ADDENDUM NO. 3

May 3, 2022

YOST ELEMENTARY SCHOOL ADDITIONS AND RENOVATIONS
Chesterton, IN 46304

Addendum Three (AD.03) to the drawings and specifications prepared by Gibraltar Design for **New Newton Yost Elementary School** for Duneland School Corporation, Chesterton, Indiana.

1 UNIT "C" FIRST FLOOR FINISH PLAN
A-803 1/8" = 1'-0"

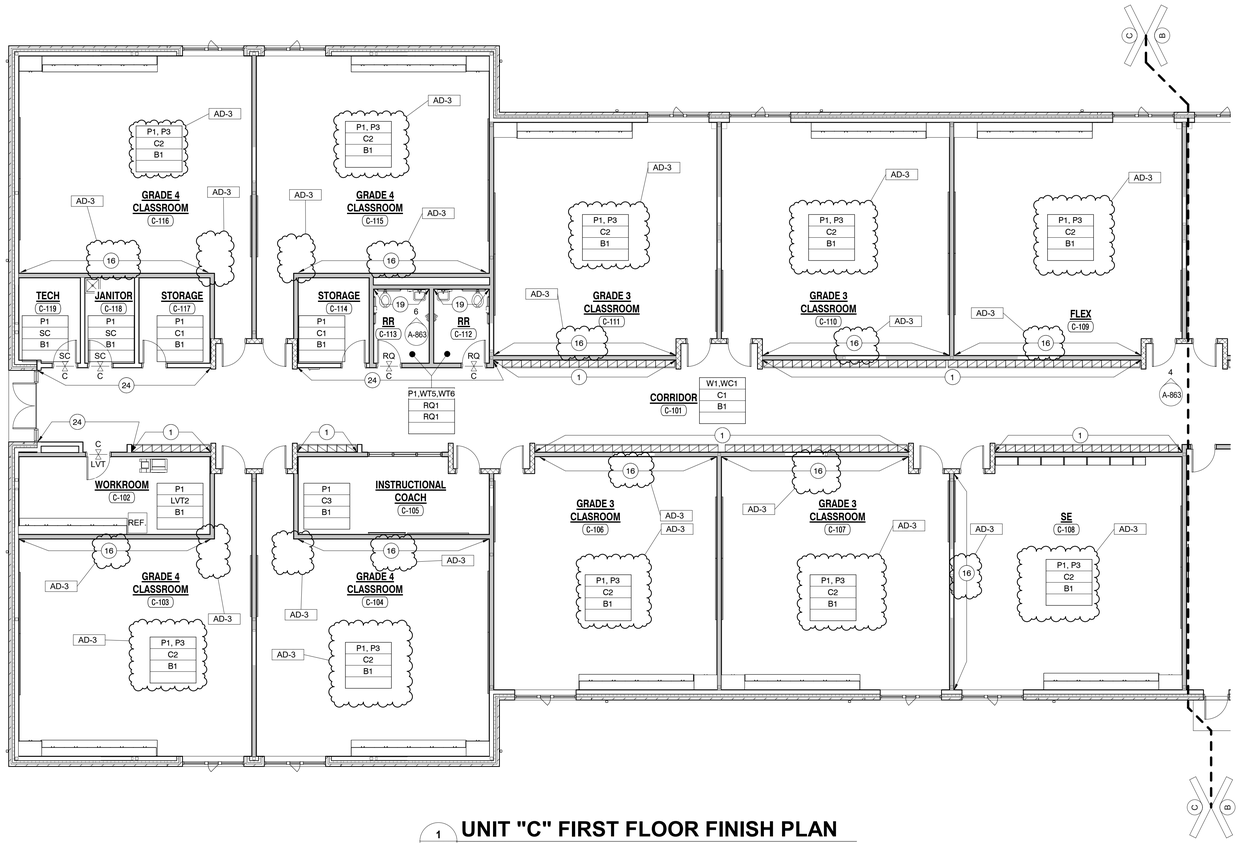
75. Sheet A-803

1 A-804 UNIT "D" FIRST FLOOR FINISH PLAN

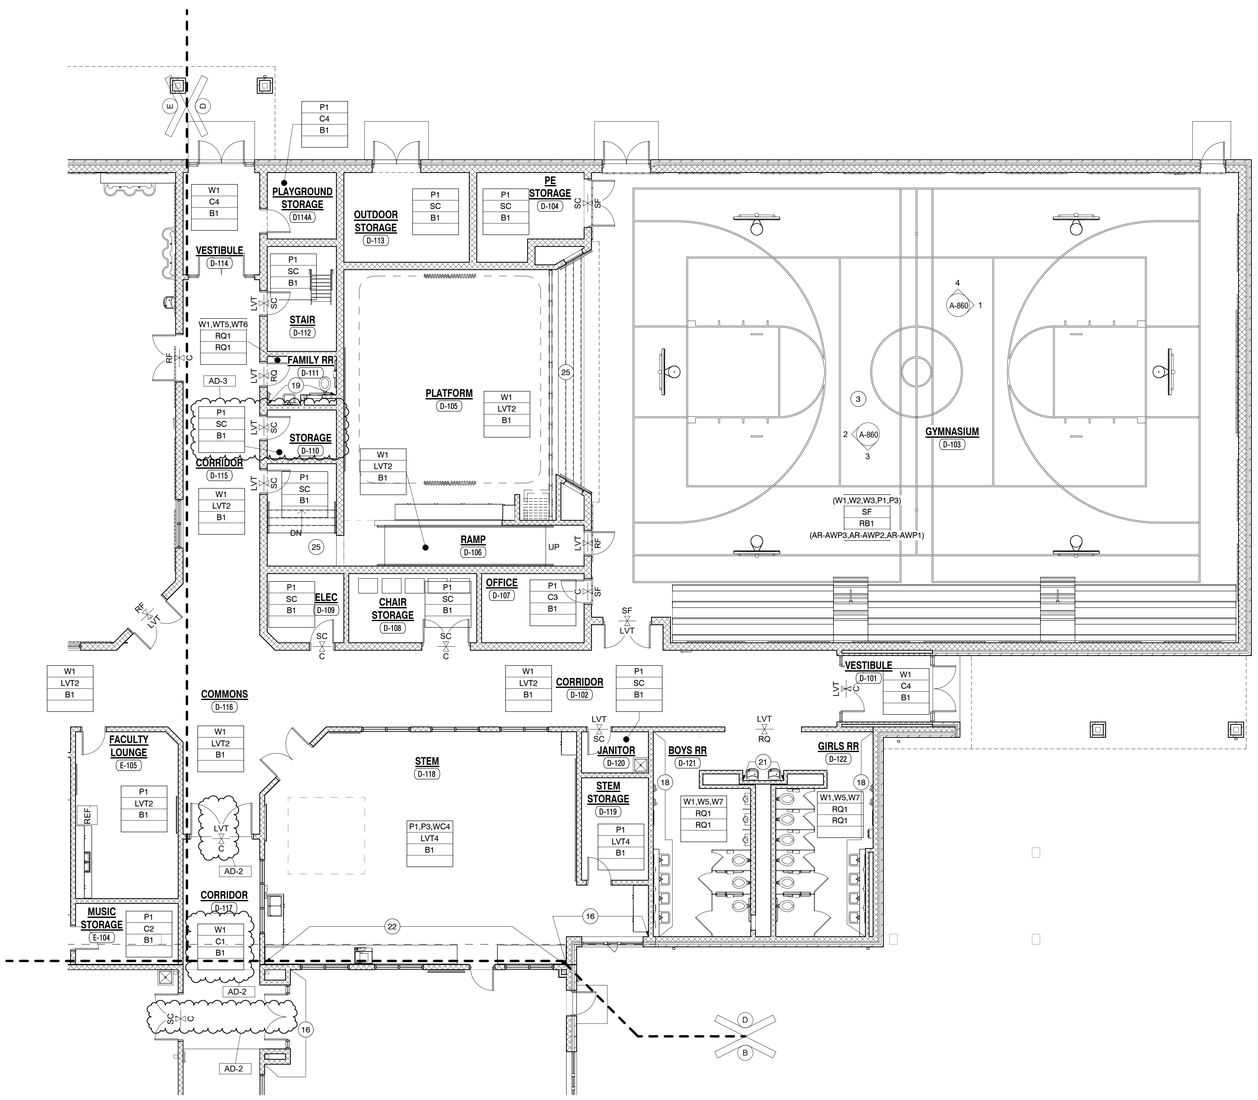
76. Sheet A-804

1 MV104 UNIT "D" MECHANICAL VENTILATION FIRST FLOOR PLAN

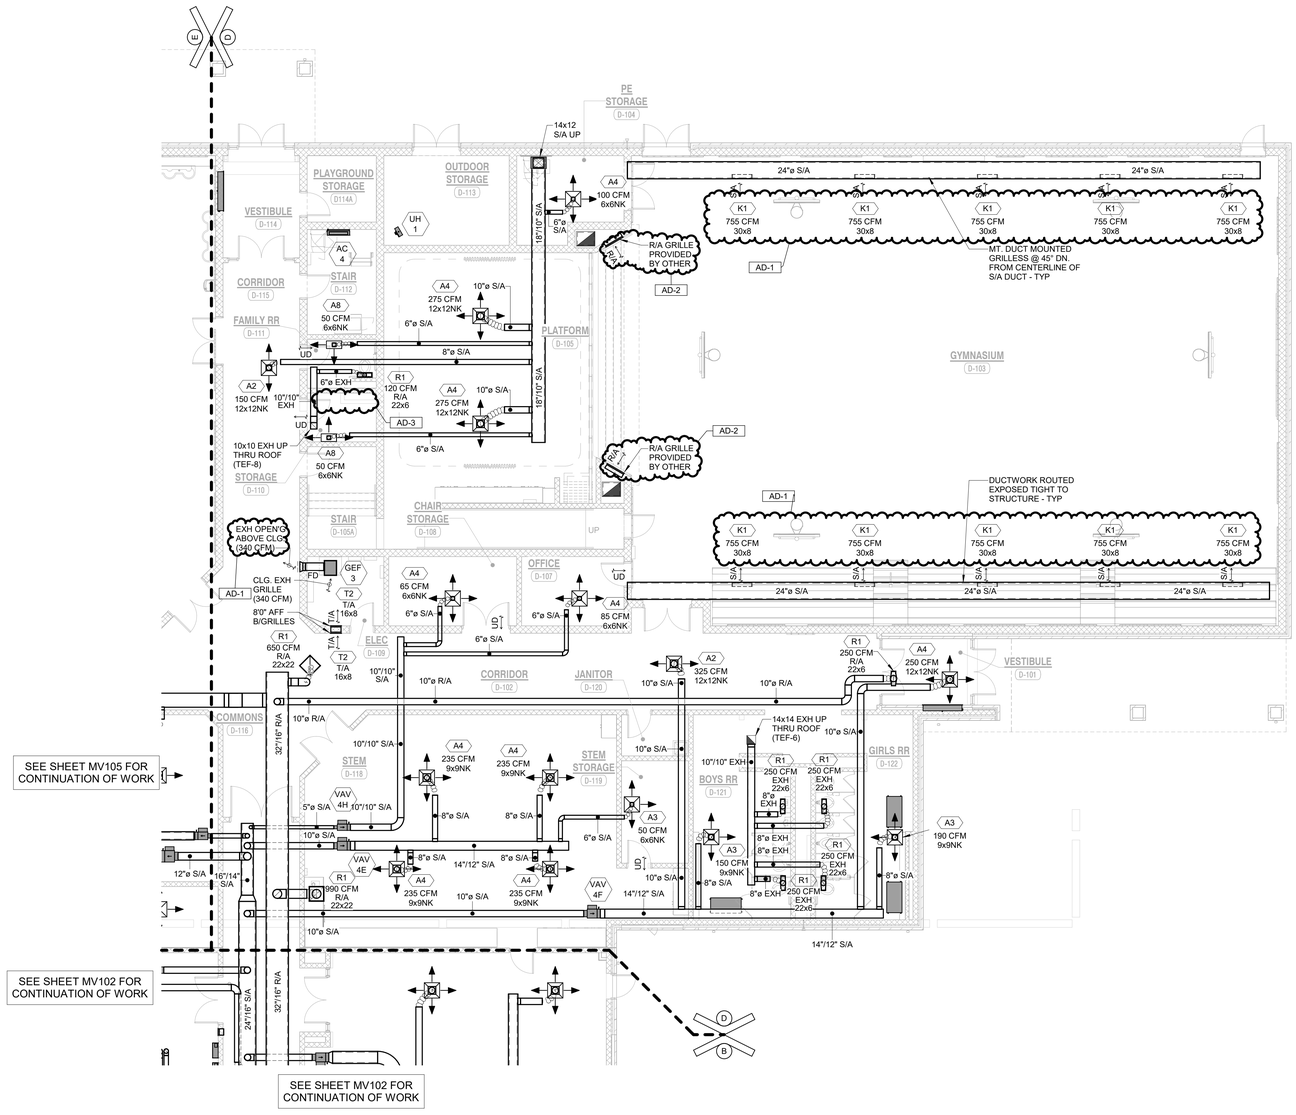
82. Sheet MV104

1 P-103 UNIT "C" PLUMBING UNDERFLOOR PLAN

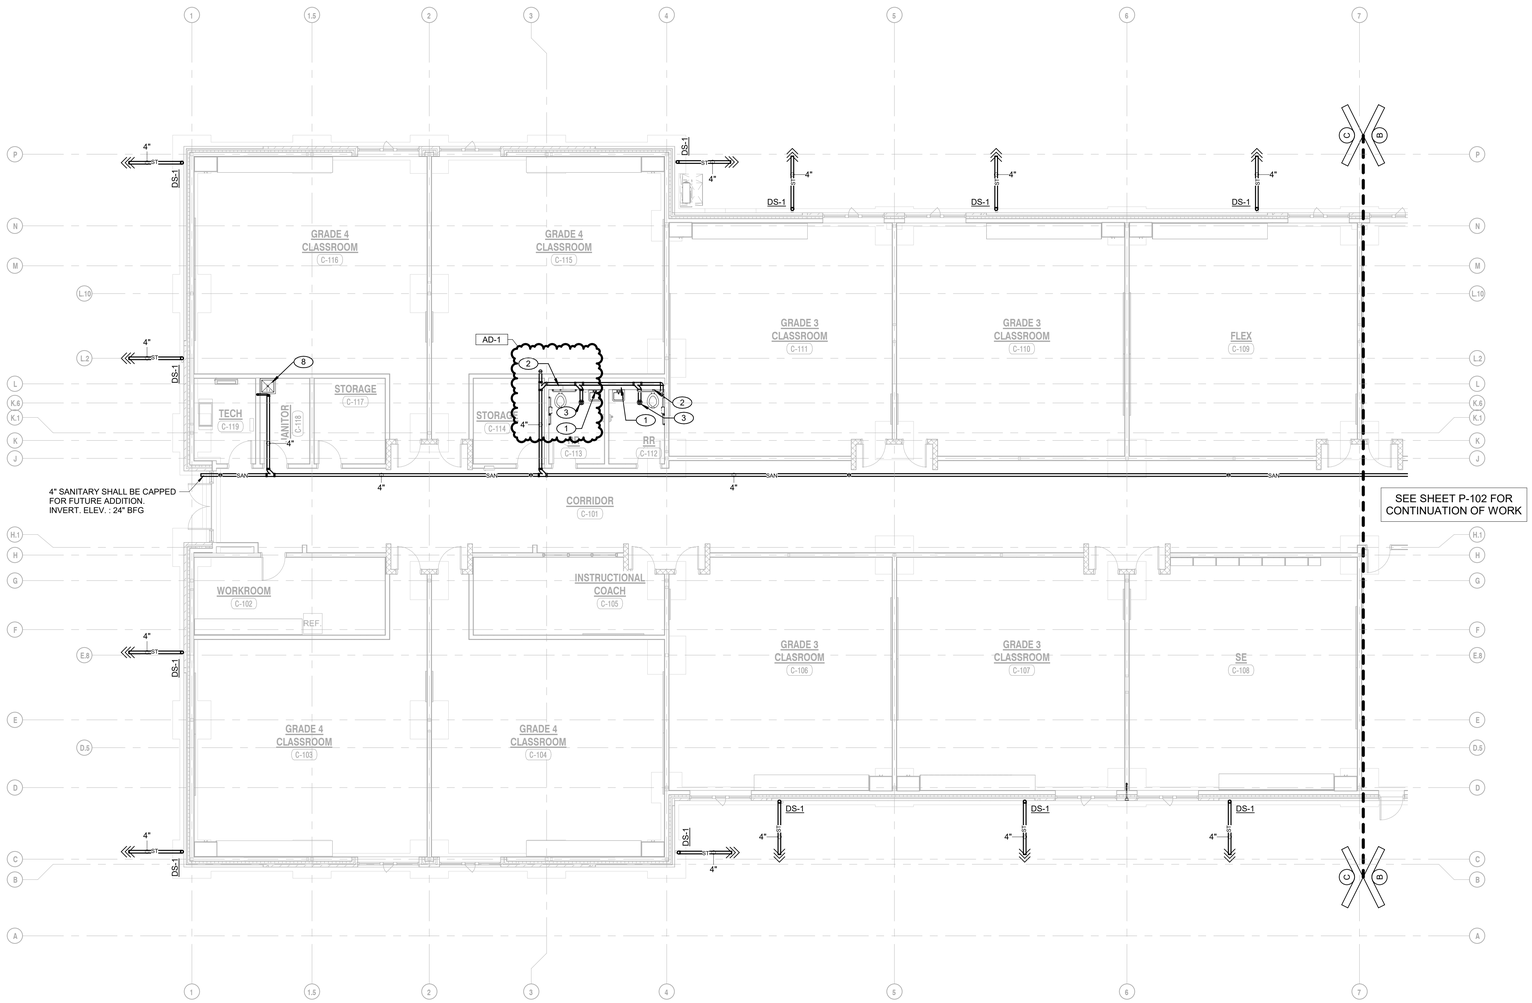
84. Sheet P-103

1 UNIT "D" PLUMBING FIRST FLOOR PLAN
P-204 1/8" = 1'-0"

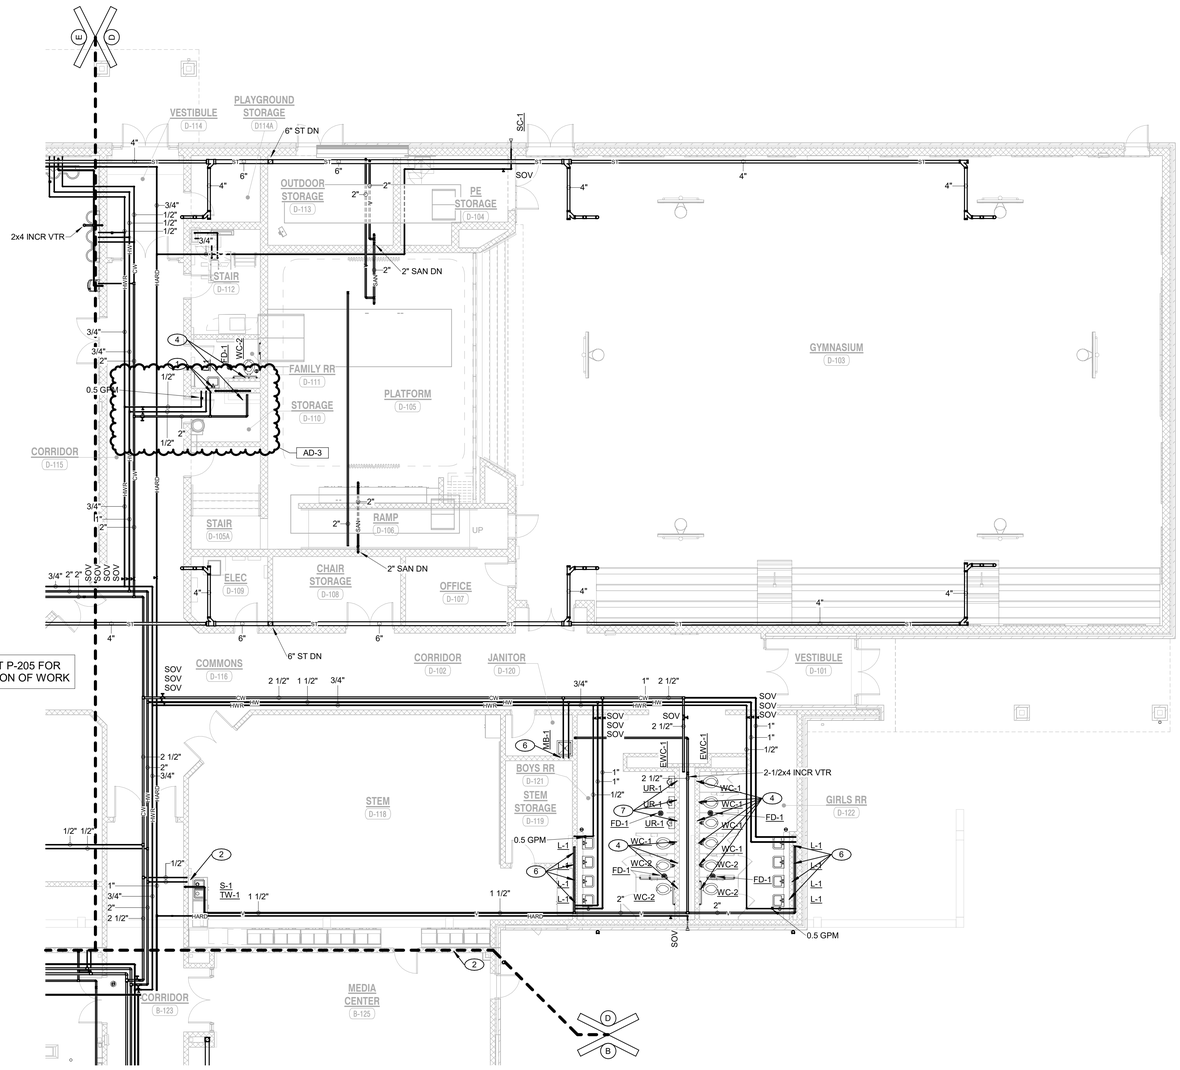
86. Sheet P-204

1 UNIT "E" ELECTRICAL LIGHTING FIRST FLOOR PLAN
EL105 1/8" = 1'-0"

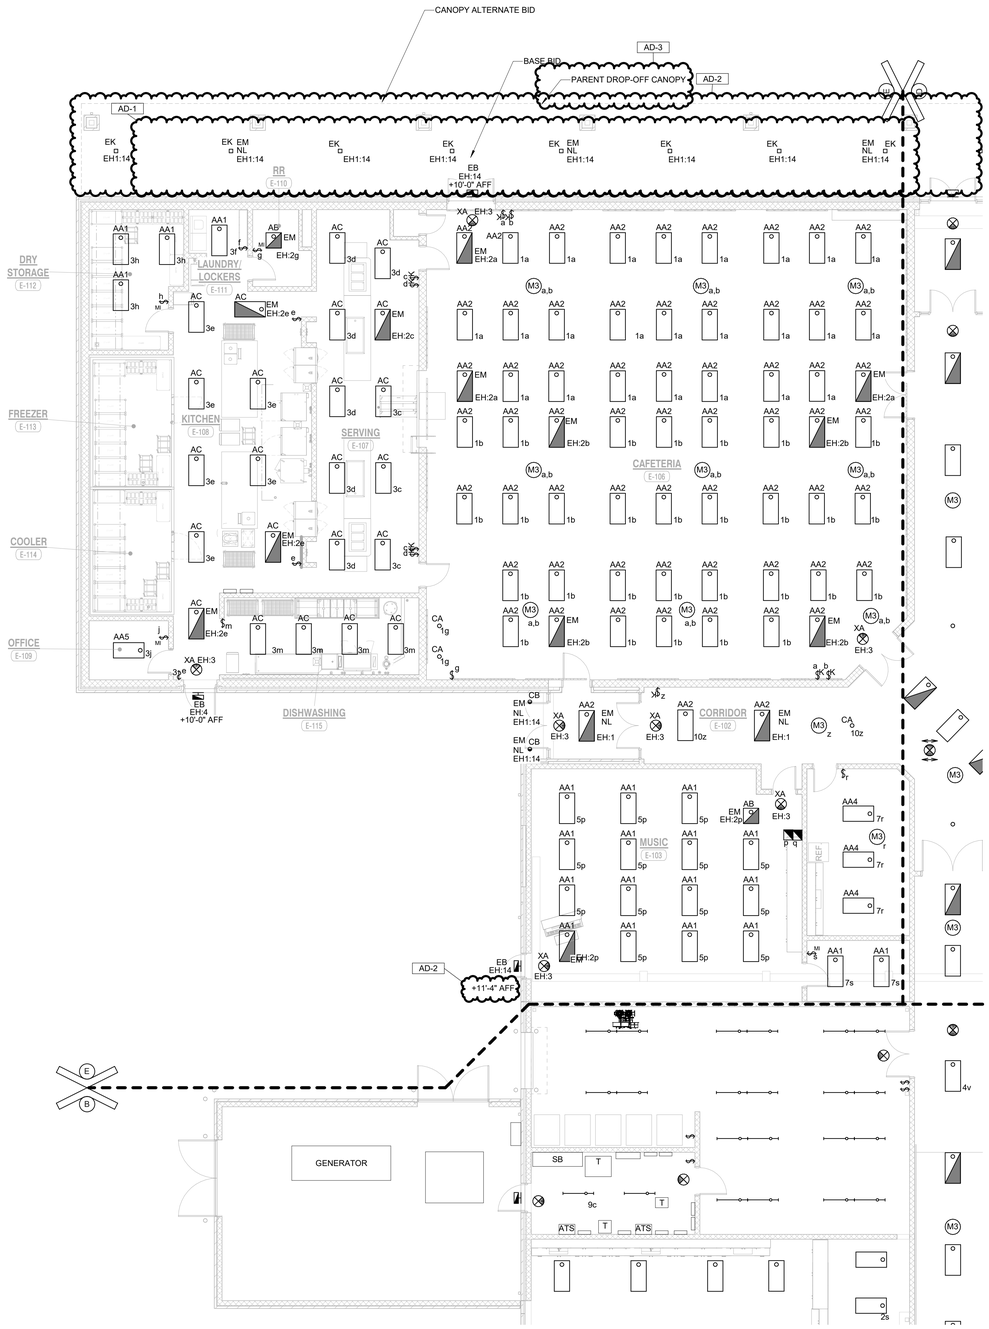
92. Sheet EL-105

1 EP101 **UNIT "A" ELECTRICAL POWER FIRST FLOOR PLAN**
1/8" = 1'-0"

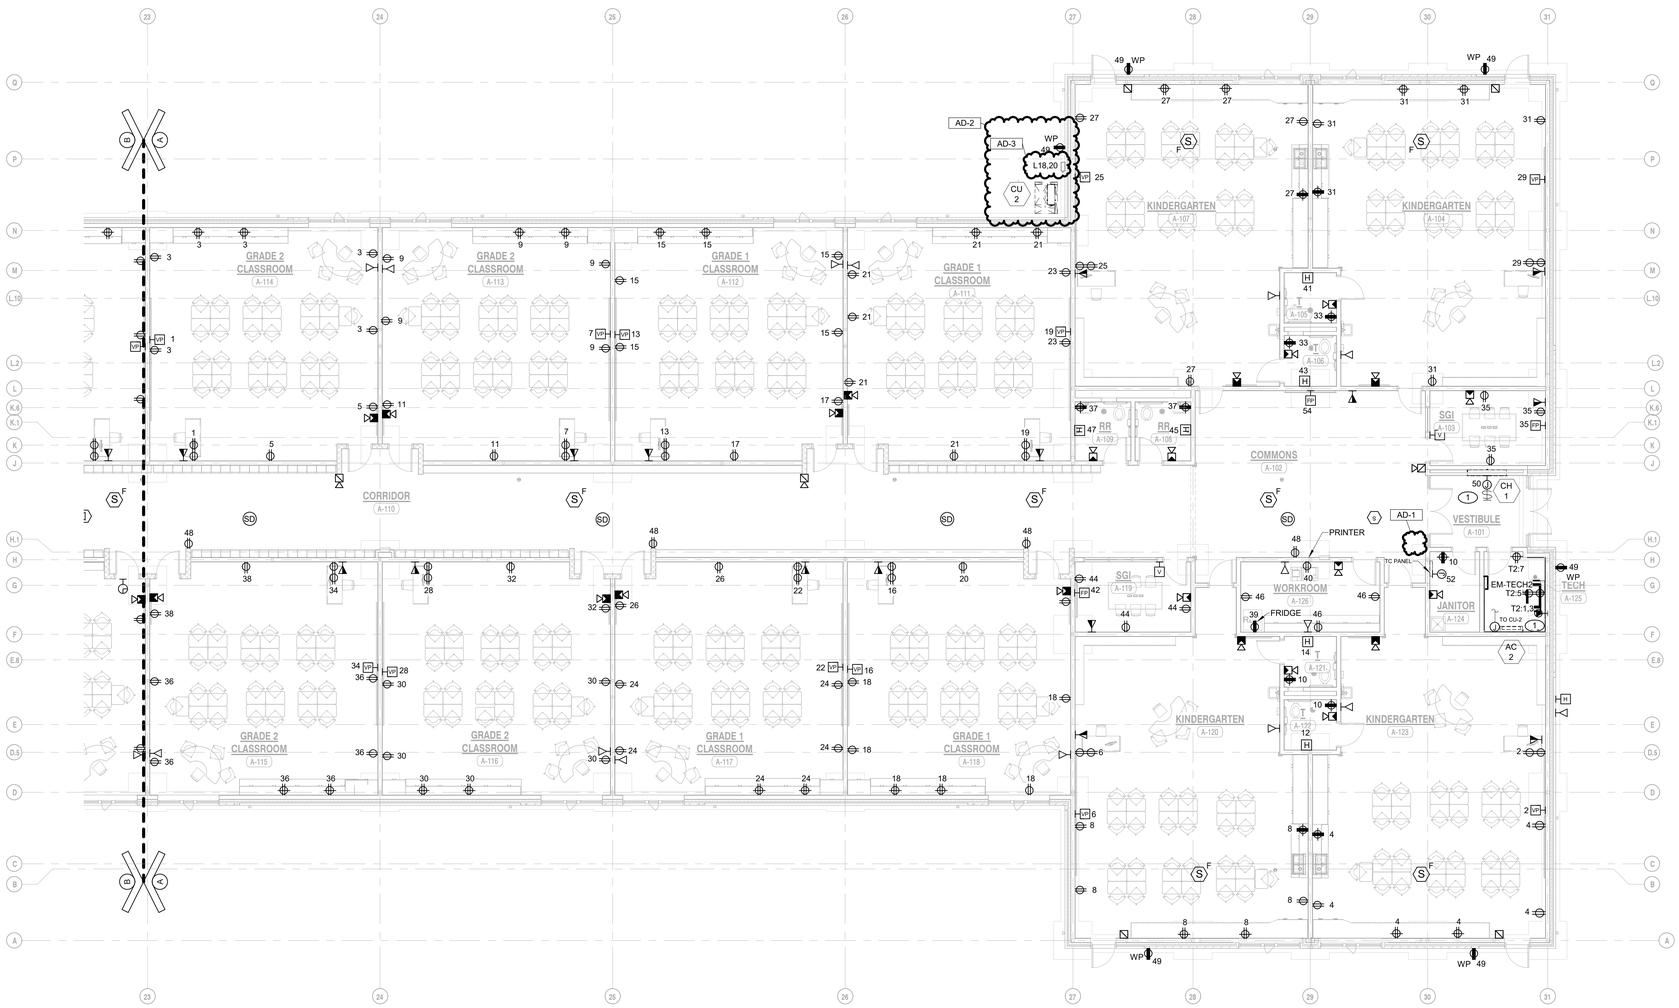
93. Sheet EP-101

1 EP103 UNIT "C" ELECTRICAL POWER FIRST FLOOR PLAN

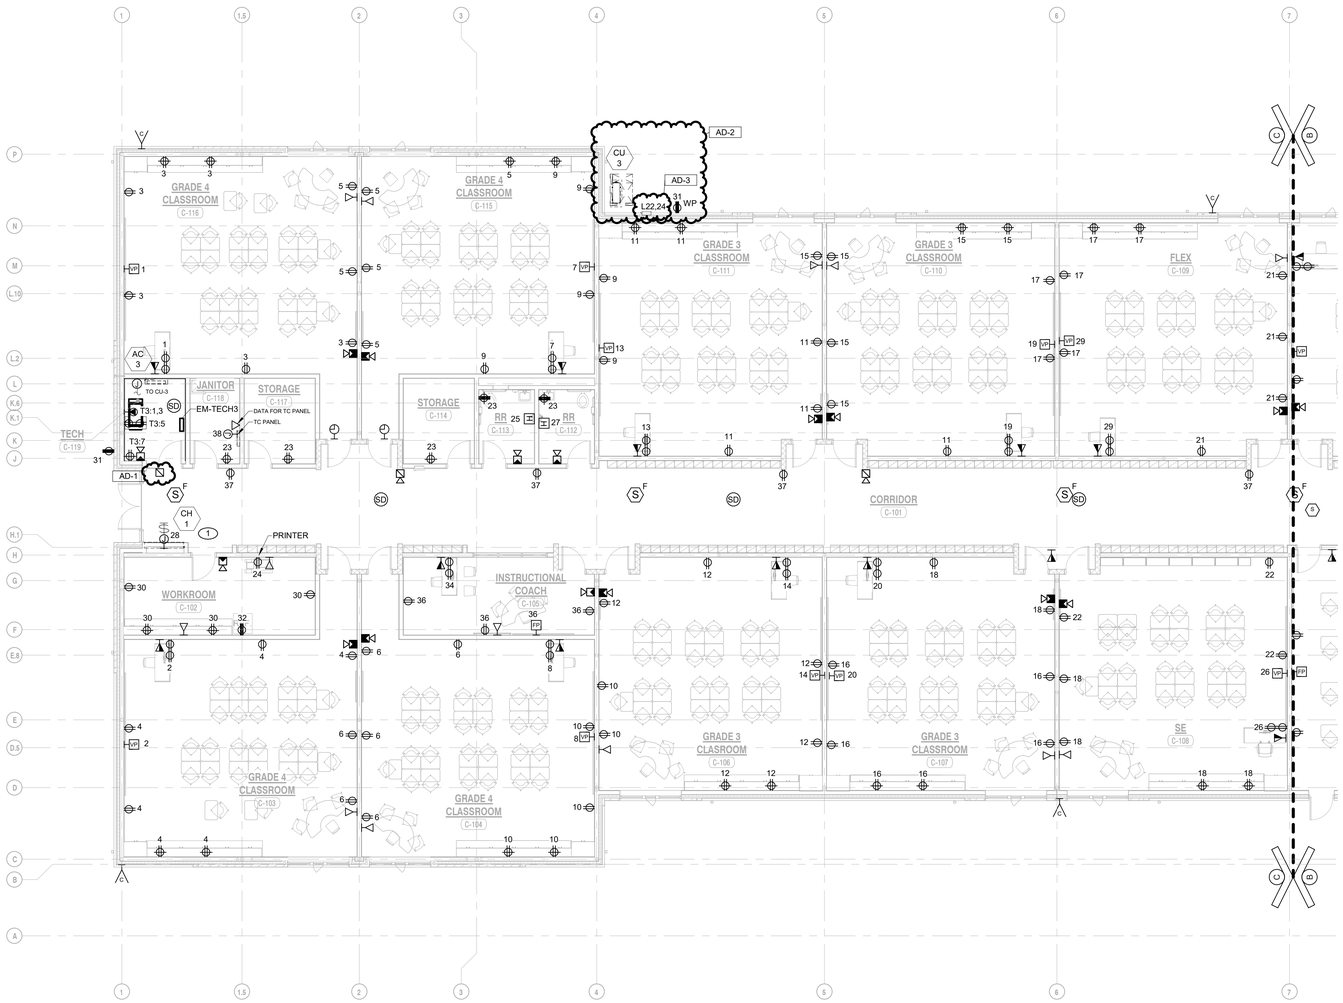
94. Sheet EP-103
